DEPARTMENT OF TRANSPORTATION - District 4 Toll Bridge Program

Contract No. 04-0120F4
04-SF-80-13.2 / 13.9
Self-Anchored Suspension Bridge
Letter No. 05.03.08-000021

Tower Struts

Figure 1

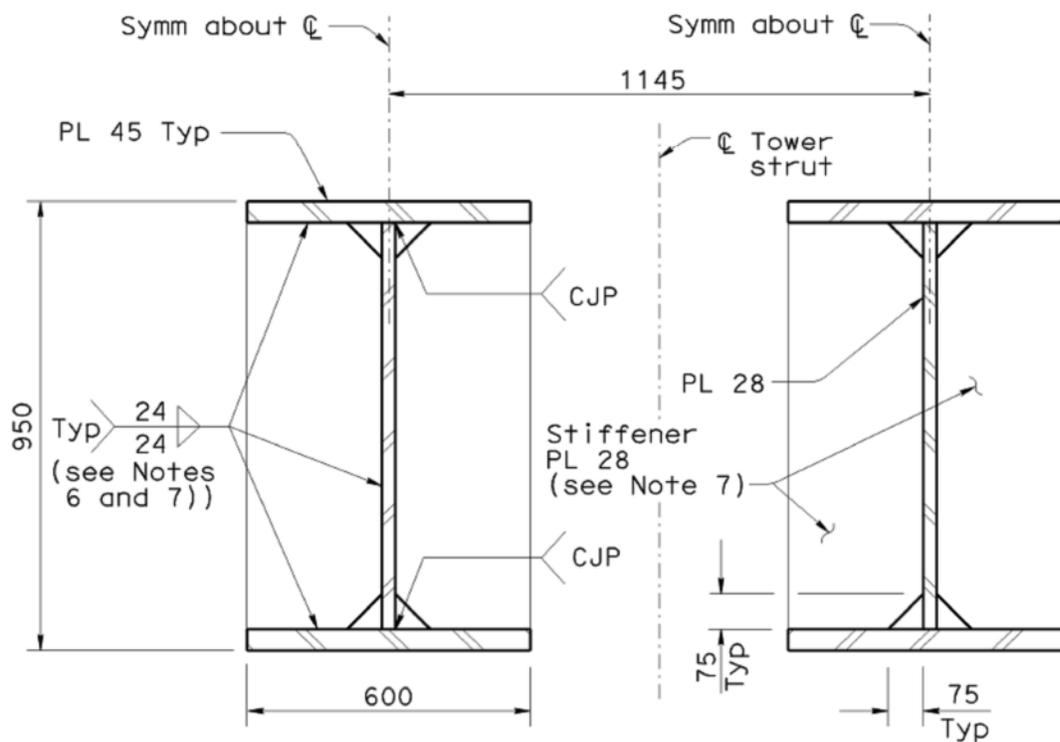
Type 1, 2, and 3 tower struts are currently being fabricated by ZPMC on Changxing Island. The contract plans call for double-sided fillet welds – of 24mm, 14mm, and 22mm for strut types 1, 2, and 3 respectively – from the stiffeners to the web and flange plates. Typical fillet weld symbols for the stiffener to web and flange plate welds for Type 1 struts are shown in Figure 1 below (Type 2 and Type 3 struts are detailed similarly.)

Notes on *Tower Strut Details No. 3, 5, and 7* (sheets 564, 566, and 568/1204 of the contract plans) specify that “*The termination of the fillet weld between the stiffener and the web shall have a 1:1 slope and shall be ground smooth.*” With the 75 chamfer, shown in Figure 1 above, changed to the 75mm cope as requested in ABF-RFI-1318R01 and approved by the Engineer on 29-April-2008, the fillet weld terminations are required by the contract specifications to be as shown in Figure 2 below.

Figure 2

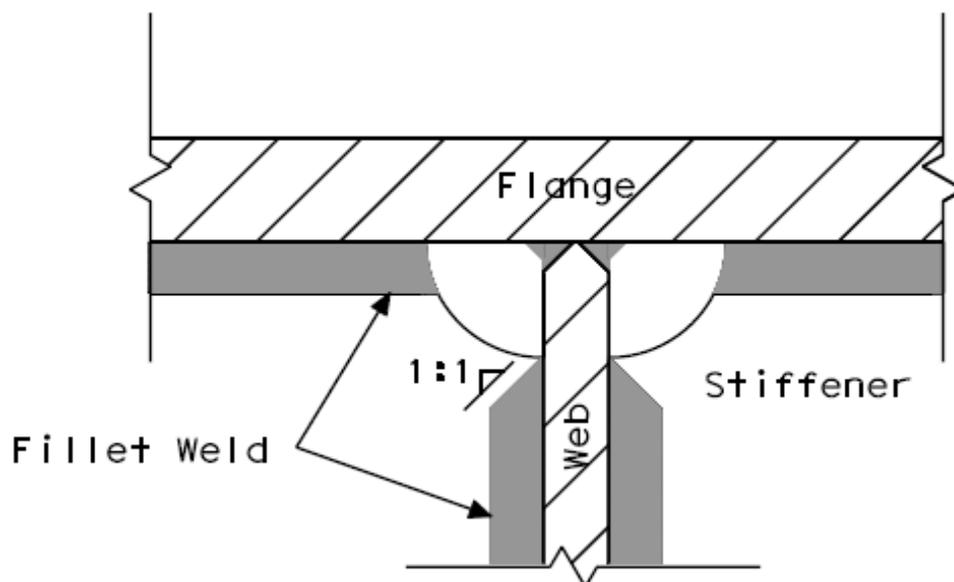
Unfortunately, the typical as-fabricated struts at ZPMC have oversized fillet welds that extend along the stiffener/web joints and continue into the copes with full wrap-arounds. These wrap-arounds, also known as boxing as defined in Figure 23 (F) of AWS A3.0: 2001, if required, would have been indicated on the design drawings as specified in Section 2.8.1.7 of AWS D1.5M: 2002. The presence of these wrap-arounds in the stiffener/web cope creates a stress concentration that reduces the shear deformation capacity and seismic performance of the shear links. Therefore, wrapping the stiffener to web fillet welds into the copes in future struts will not be acceptable to the Department; and struts already fabricated with wrap-arounds must be mitigated.

Figure 3 - Retrofit Strategy

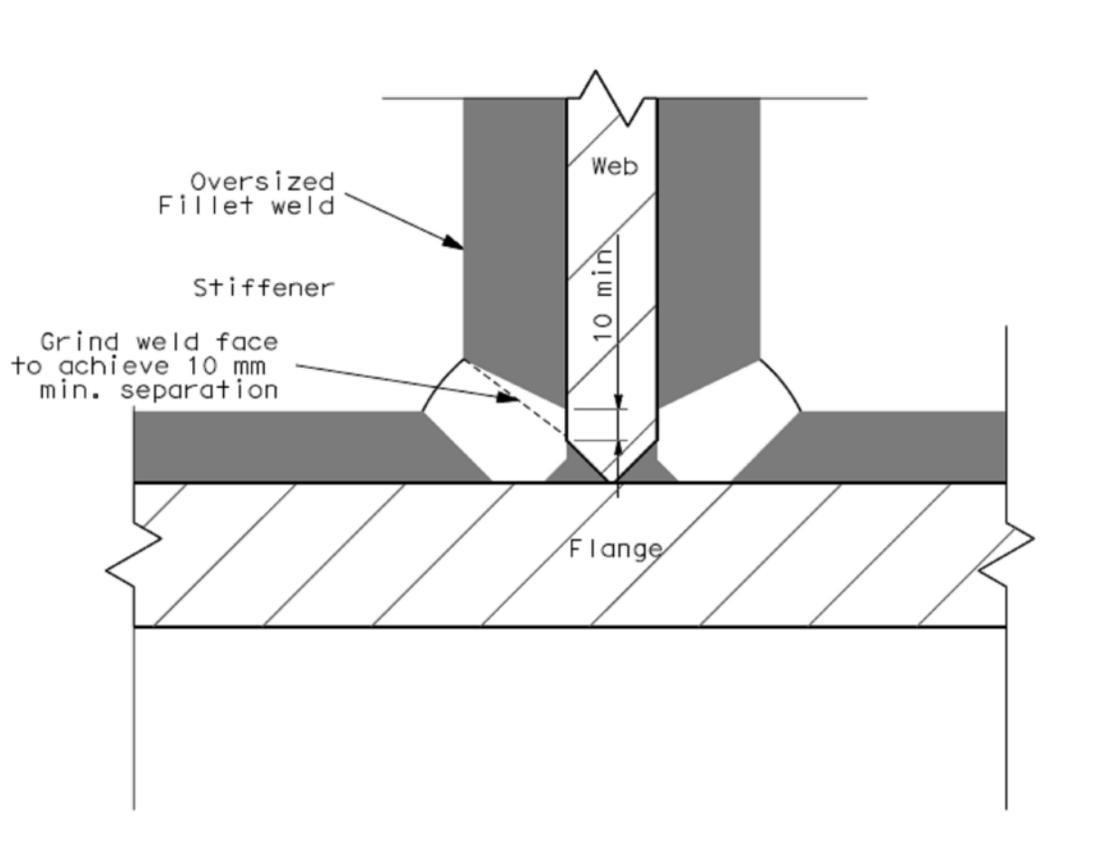
Notwithstanding 42 of the fabricated struts have been previously green-tagged, struts not in contract compliance must be remedied and repaired by the Contractor at his expense, or they will be rejected. In order to minimize impacts on ABF and ZPMC, struts previously fabricated and green-tagged will be found acceptable as long as the following minimum requirements are achieved:

1. The weld profile inside the copes shall be feathered and ground smooth.
2. There shall be no sharp edges in the wrap-around of the web-to-stiffener fillet weld.
3. The clear distance between the toe of the web-to-stiffener fillet weld and the toe of the flange-to-web reinforcing fillet weld shall be a minimum of 10-mm as shown in Figure 3 below.
4. For the first and last stiffeners on each end of the strut (where the web and flange plates have a thickness transition), item 3 shall not apply. In those locations, the toes of each weld shall be blended smooth.
